Access Compliance Report

Public Rights-of-Way

Intersection ID: 53351	Main Street: MARVIN_RD	Cross Street: SAPPHIRE_HILL_LN	Location: NW
ADA ID: F76E6CEDC1E1	Ramp Type: Perp	Initial Pass/Fail: Fail	Overall Compliance: No
Severity Score: 33.75			
Codes/Mitigation Info/Possible Solution		Field Measurements/Component Compliance

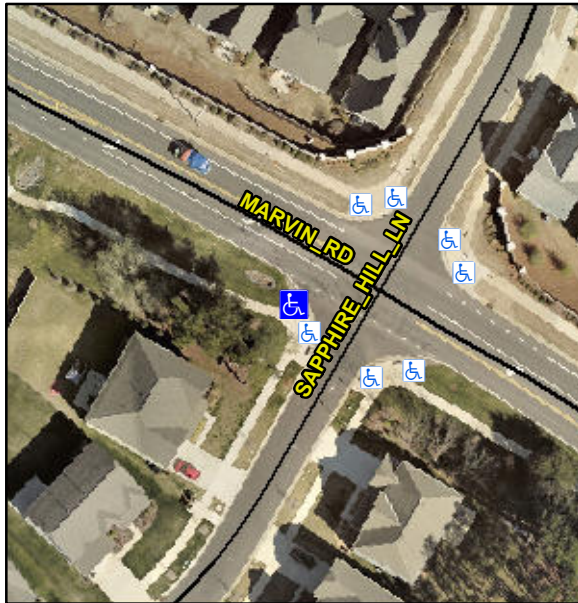
Not Found, R304.5.1, R304.5.3

Compliance	Description	Data	Compliance	Description	Data
N/A	Ramp Length (in)	105.0	Yes	Ramp Slope (%)	7.1
No	Ramp Width (in)	47.0	No	Ramp XSlope (%)	7.4
N/A	Flare Type LT	N/A	N/A	Flare Type RT	N/A
N/A	Flare Slope LT (%)	N/A	N/A	Flare Slope RT (%)	N/A
N/A	Flare Traversable LT?	N/A	N/A	Flare Traversable RT?	N/A
N/A	Landing Length (in)	N/A	N/A	DWS Provided?	N/A
N/A	Landing Width (in)	N/A	N/A	DWS Contrast?	N/A
N/A	Landing Slope (%)	N/A	N/A	DWS Length (in)	N/A
N/A	Landing X Slope (%)	N/A	N/A	DWS Full Width?	N/A
N/A	Landing Curb? (Y/N)	N/A	N/A	DWS Offset (in)	N/A
N/A	Shared Landing?	N/A			
N/A	Gutter Ponding?	N/A	N/A	Gutter Slope (%)	N/A
N/A	Gutter Lip Ht (in)	1.0	N/A	Gutter X Slope (%)	N/A
N/A	Painted X Walk1?	No	N/A	Painted X Walk2?	N/A
	X Walk 1 Direction	To NE		X Walk 2 Direction	N/A
N/A	X Walk 1 Width (in)	N/A	N/A	X Walk 2 Width (in)	N/A
	X Walk 1 Slope (%)	8.7		X Walk 2 Slope (%)	N/A
	X Walk 1 X Slope (%)	3.6		X Walk 2 X Slope (%)	N/A

Remove & Replace Entire Ramp.
